AUI-C2C transmitter equalization control interface proposal

(Addressing comments 11059, 11082)

Adee Ran, Intel

Figure 120F-2—Typical 100GAUI-1, 200GAUI-2, and 400GAUI-4 C2C application

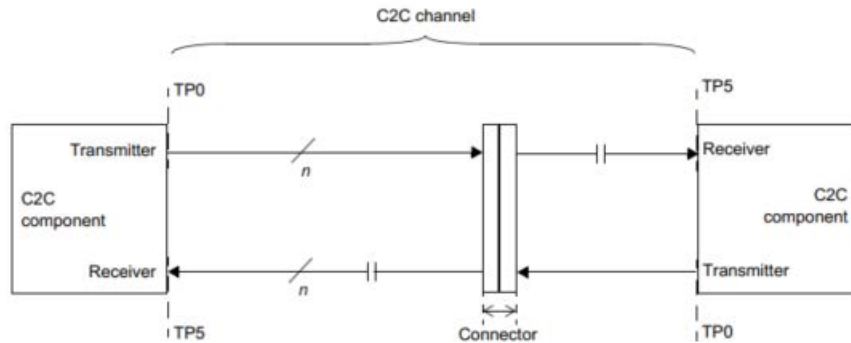
The 100GAUI-1, 200GAUI-2, and 400GAUI-4 C2C transmitter on each end of the link is adjusted to an appropriate setting based on channel knowledge. If implemented, the transmitter equalization feedback mechanism described in 120D.3.2.3 may be used to identify an appropriate setting. The adaptive or adjustable receiver performs the remainder of the equalization.

Annex 120F text refers to a control interface of 120D - 3-tap TxEq using absolute tap values

3 Change as shown
 The 100GAUI-1, 200GAUI-2, and 400GAUI-4 C2C transmitter on each end of the link is adjusted to an appropriate setting based on channel knowledge. If implemented, the transmitter equalization feedback mechanism described in 120D.3.2.3 may be used to identify an appropriate setting. The adaptive or adjustable receiver performs the remainder of the equalization.

The 100GAUI-1, 200GAUI-2, and 400GAUI-4 C2C transmitter on each end of the link is adjusted to an appropriate equalization setting, which may be based on channel knowledge. If implemented, The transmitter equalization feedback mechanism described in 120F.3.1.5 may be used to identify an appropriate setting of the link partner. The adaptive receiver performs the remainder of the equalization.

Figure 120F-4—Transmitter equalizer functional model

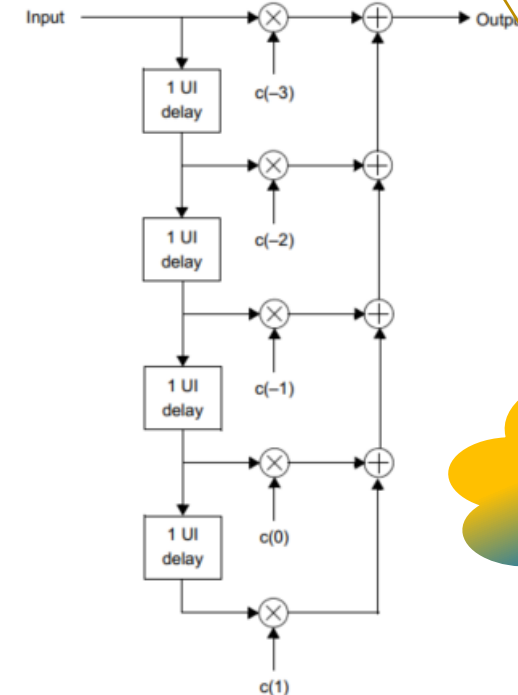
The TxEq is specified with 5 taps

Mess...
A new control interface is required

6 Change as shown
 Each transmitter includes programmable equalization to compensate for the frequency-dependent loss of the channel and to facilitate data recovery at the receiver. The functional model for the transmit equalizer is the five-tap transversal filter shown in Figure 120F-4. Transmitter output waveform specifications are provided in Table 120F-1. The state of the transmitter output equalization is configured via management.

Each transmitter includes programmable equalization to compensate for the frequency-dependent loss of the channel and to facilitate data recovery at the receiver. The functional model for the transmit equalizer is the five-tap transversal filter shown in Figure 120F-4. Transmitter output waveform specifications are provided in Table 120F-1. The state of the transmit equalizer and hence the transmitted output waveform may be configured via the transmitter control interface described in 120F.3.1.4.
